THE CITY OF PLEASANTON

Planning Commission Staff Report

July 24, 2013
Item 6.a.

SUBJECT:	**Work Session for PUD-84**
APPLICANTS/ PROPERTY OWNERS:	Frank and Barbara Berlogar
PURPOSE:	Work session to review and provide comments on an application for planned unit development (PUD) development plan approval to subdivide an approximately 37.4-acre site with up to four lots, consisting of three new single-family lots for custom homes and one lot with the existing residence.
LOCATION:	88 Silver Oaks Court
GENERAL PLAN:	Residential – Low Density (less than 2 dwelling units per gross acres) and Open Space – Public Health and Safety
SPECIFIC PLAN:	Vineyard Avenue Corridor Specific Plan
ZONING:	PUD-HR/OS (Planned Unit Development – Hillside Residential/Open Space) District.
EXHIBITS:	A. Discussion Points B. Proposed Site Plan, Preliminary Grading Plan, Design Guidelines, and Photosimulations C. Tree Assessment Report D. Memo to Planning Commission Dated October 3, 2005 E. Site Layouts: Proposed vs Alternatives F. Ordinance 1832, Approving PUD-5 G. Vineyard Avenue Specific Plan Land Use Plan H. Letter from Silver Oaks Estates HOA and Emails from Gevan Reeves I. Project Location/Notification

Hillside Residential Land Use in mustard color and Proposed Residential Lots

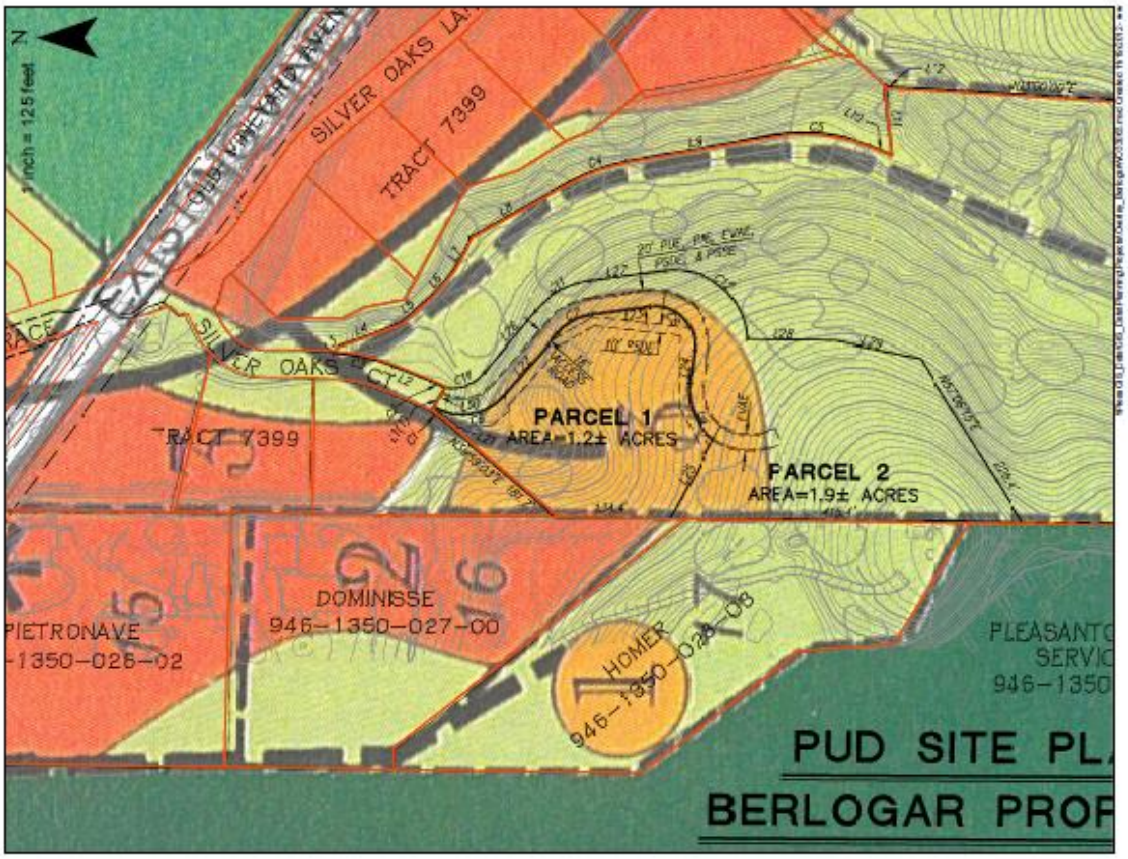
As shown in the exhibit above, the proposed Lot 1 and a portion of the proposed Lot 2 would be located within the “mustard colored” area as identified in the VACSP Land Use Plan for hillside residential development.

The VACSP indicates that all hillside home sites must be located within the designated development areas as generally depicted (underline added) on the land use plan, the “mustard colored blob” as it was referred to. Staff notes that the land use plans are not usually meant to be precise, but can be flexible.

The Silver Oaks Estates HOA stated in its letter that locating lots/homes outside the “blob” area would not conform to the VACSP or the specific plan’s Environmental Impact Report. If the proposed lots/homes are located entirely within the “blob” area such as the lot layout shown in one of the site alternatives (discussion later in the report), heritage-sized trees would be removed, significant grading would be required, and tall retaining walls would be constructed.

Staff believes that the proposed development plan conforms to the intent of the Specific Plan. Staff notes that land use plans are generally considered conceptual, thereby providing flexibility for the development of actual projects. Staff believes the “blob” or “dot” is conceptual and is not intended to be specific at the time these plans were made. For the seven custom home sites in the nearby site (PUD-54) on Lot 25 of the VACSP, the Commission and Council allowed some of the hillside residential home sites to be located outside the area shown on the Land Use Plan without a Specific Plan Amendment. Likewise, staff believes that the proposed lots could be located within the general vicinity of the location shown on the land use plan without a Specific Plan Amendment.

Alternative No. 1 – Three New Residential Lots

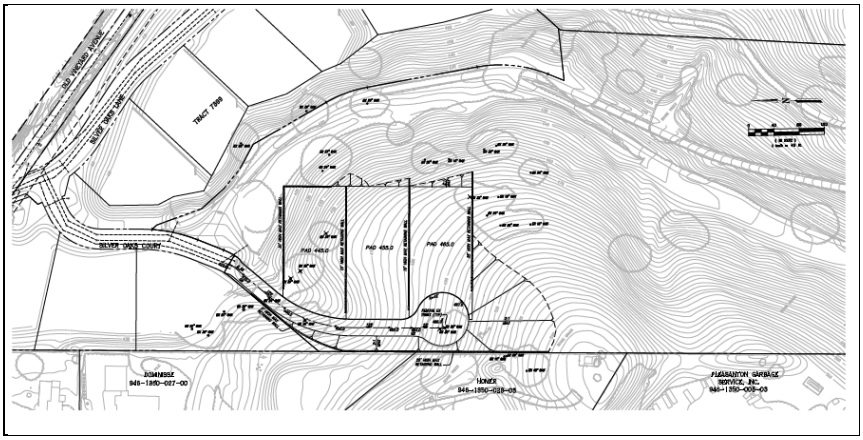
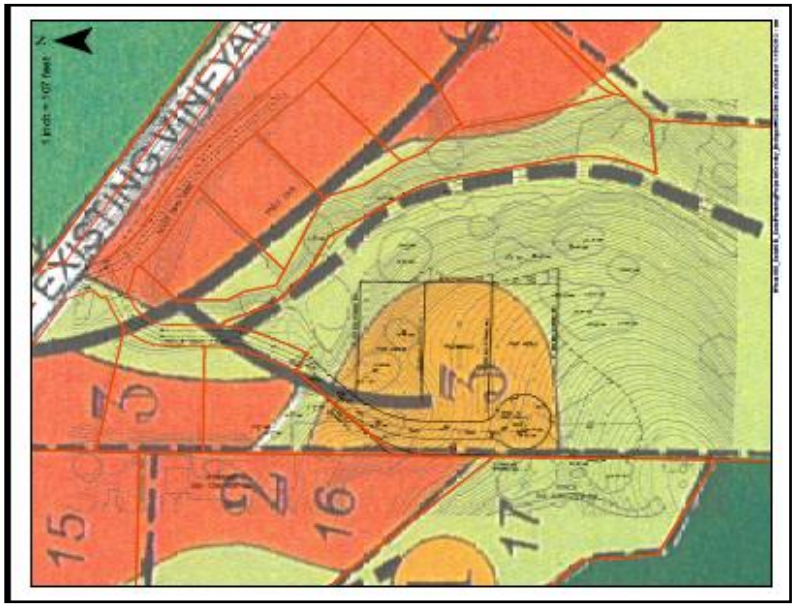
- Except for a small portion of Lot 1 and Lot 3, this three-lot site alternative fits inside the Hillside Residential area as depicted in the Specific Plan's Land Use Plan;
- The slope of the road varies from 6% to 19%;
- An eight-foot high retaining wall is needed along the west side of the proposed road;
- Retaining walls varying between 10- to 25-foot in height are located between the residential lots;
- Eight heritage-sized oak trees would need to be removed;
- Pad elevations for the three new lots are: Lot 1 at 445'; Lot 2 at 455'; Lot 3 at 465';
- Lot sizes of the three new lots are: Lot 1- approx. 19,795 sq.ft.; Lot 2 – approx. 21,025 sq.ft., Lot 3 – approx. 18,117 sq.ft.
- The total area of disturbed slope is approx. 98,843 sq.ft.

From the proposed alternatives, Alternative No. 1 may be revised slightly so that all three new residential lots would fit within the Hillside Residential area and responds to HOA's concern of compliance to the specific plan. However, this alternative would result in significant grading and retaining walls, and would remove eight heritage-sized oak trees. It may not address the disruptive visual impacts raised by the Silver Oaks Estates HOA in terms of retaining walls and intrusive privacy issue from the proposed three new homes to the existing homes on Silver Oaks Lane.

Alternative No. 2: Two New Residential Lots

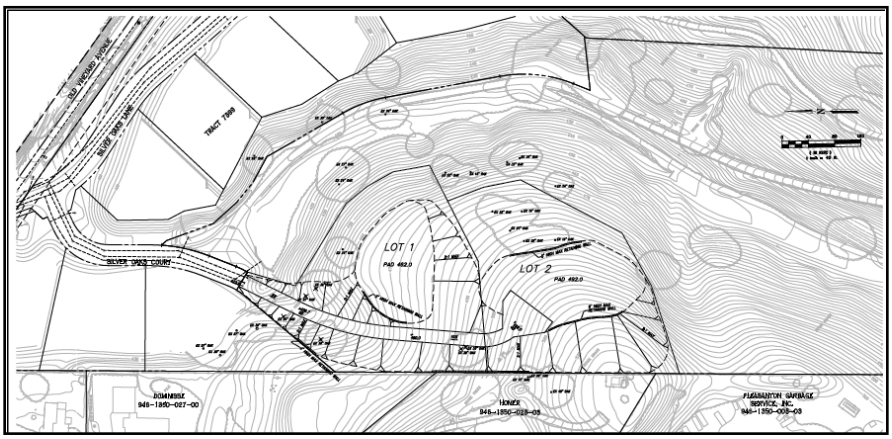
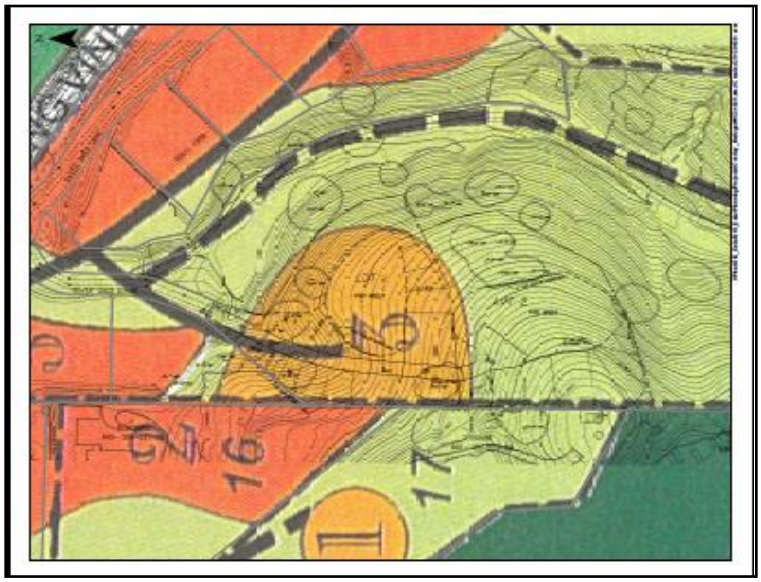
- Two new residential lots with most of Lot 2 outside the Hillside Residential area as depicted in the Specific Plan's Land Use Plan;
- The lope of the road varies from 6% to 12%;
- A four-foot high retaining wall is needed along the west side of the proposed road;
- A two-foot high retaining wall is needed on Lot 1;
- Two retaining walls, 5 and 6 feet in height, are needed on Lot 2;
- Six heritage-sized oak trees would need to be removed;
- Pad elevations for the two new lots are: Lot 1 at 462'; Lot 2 at 492';
- Building envelope area for the two new lots are: Lot 1 – approx.17,140 sq.ft., Lot 2 – approx. 21,938 sq.ft.
- The total area of disturbed slope is approx.107,541sq.ft.

Neither Alternative No. 2 nor Alternative No. 3 fits within the Hillside Residential area. The proposed road on Alternative No. 2 is very steep, exceeding the maximum slope which is acceptable to the Fire Department. Both alternatives would result in removal of several heritage-sized oak trees.

Alternative No. 3 – Two New Residential Lots

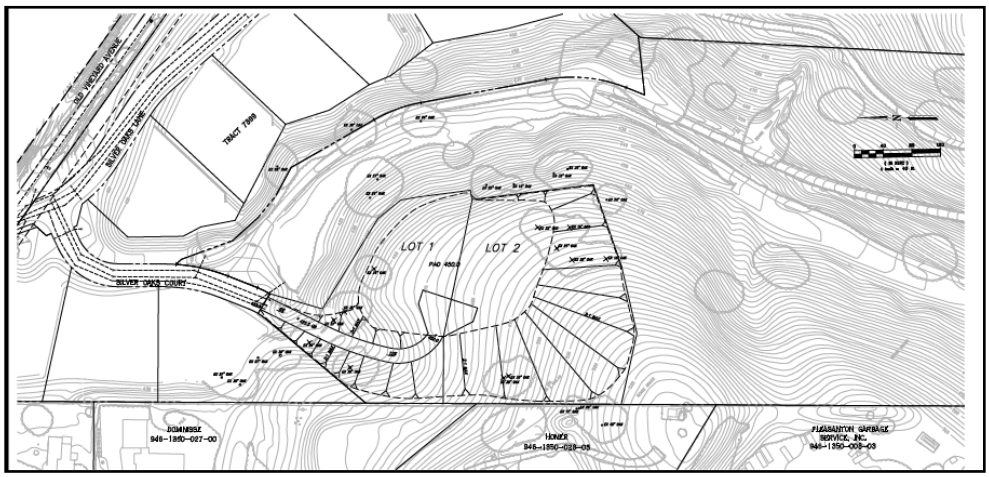
- Two new residential lots with Lot 2 partially outside the Hillside Residential area as depicted in the Specific Plan Land Use Map;
- The slope of the road varies from 6% to 12%;
- No retaining walls are proposed;
- Six heritage-sized oak trees would need to be removed;
- Pad elevation for both lots is at 450'.
- Building envelope area for the two new lots are: Lot 1 – approx. 21,974 sq.ft., Lot 2 – approx. 20,621sq.ft.
- The total area of disturbed slope is approx. 107,037 sq.ft.

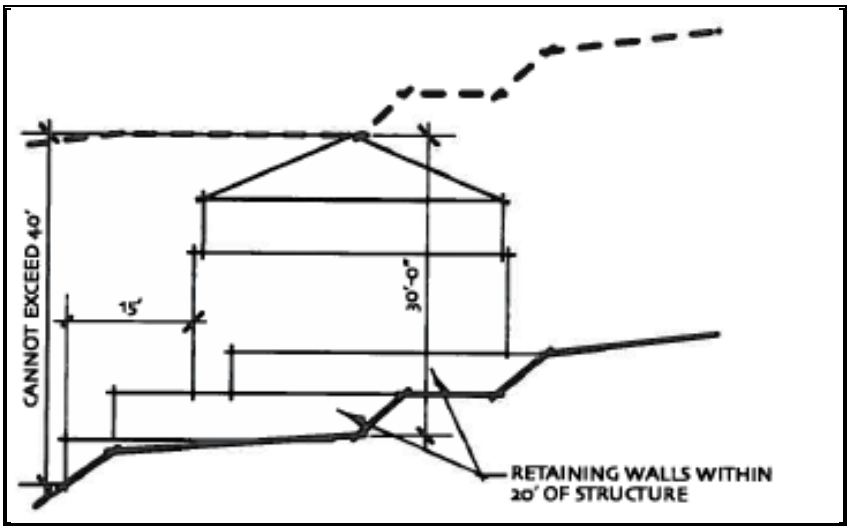
The home on Lot 1 would be a split-level home to minimize grading; thus, the proposed house pad on Lot 1 would be located on elevations of 460 feet and 470 feet, and the proposed house pad on Lot 2 would be located on elevation 515 feet. The proposed home design guidelines require the homes to be designed to integrate into the hillside setting or a split-level design. Regarding height, the design guidelines require, at any point on the plane of any visible elevation, the height of the structure, measured from the existing grade to the highest point of the finished roofing, shall not exceed 30 feet. The overall height of the structure, measured

from the lowest natural grade when the house is constructed to the highest point of the finished roofing, shall not exceed 40 feet. See illustration below (pg. 12 of the proposed design guidelines, Exhibit B).

Page 23 of VACSP states site development standards such as building height may vary for unusual site conditions as long as any new standards are consistent with the intent of the Specific Plan. Page 24 states minor variations in lot, building setbacks, and building height may be permitted subject to the PUD development plan approval process where necessary due to physical site conditions.

Discussion Point No.3: Is the proposed building height specified in the design guidelines acceptable?
